Subject: N232400840 - Customer Satisfaction Program
Incorrect Charging Time on Fuel Economy Label

Models: 2023 Chevrolet Bolt EV

N232400840 Incorrect Charging Time on Fuel Economy Label

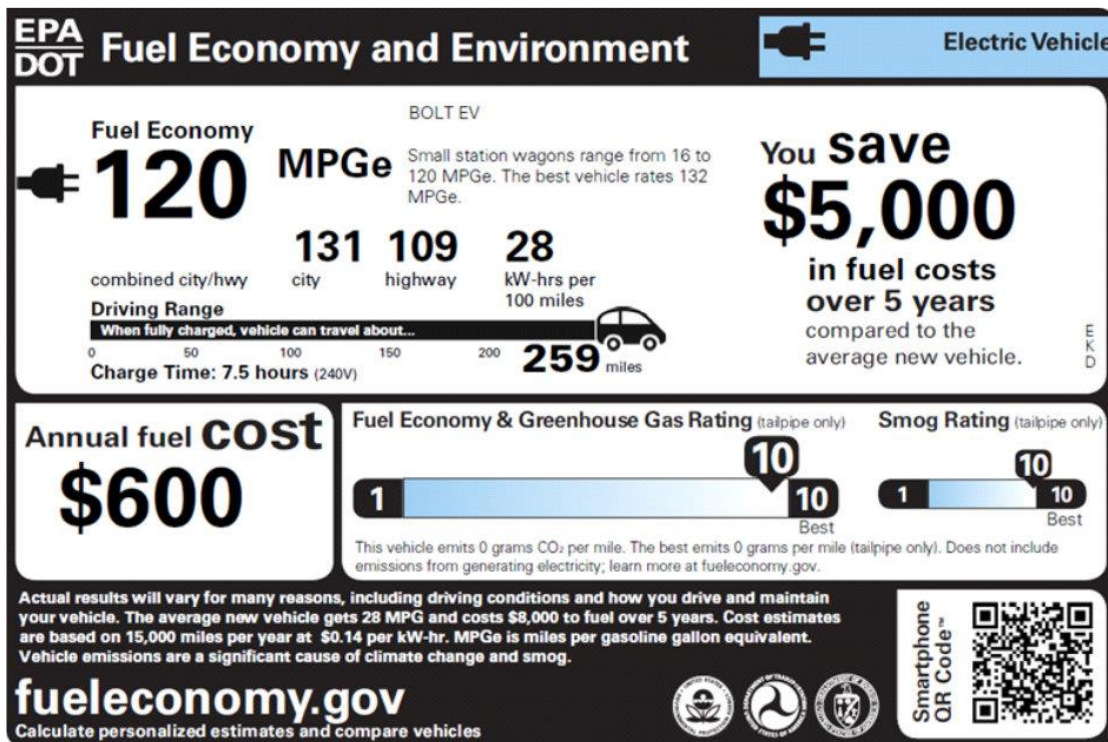
Condition	Certain 2023 model year Chevrolet Bolt EV vehicles may have a window fuel economy label that, due to a printing error, did not state the vehicle's battery charge time. The corrected labels shown below include the battery charge time of 7.5 hours.
Correction	Corrected fuel economy labels are being mailed to customers of record. For vehicles in dealer inventory or if you have a customer that has lost, ripped or destroyed a label and needs to replace it, dealers are to print the fuel economy label below and place it in the owner's glovebox.

Print the fuel economy label and place it in the owner's glovebox.
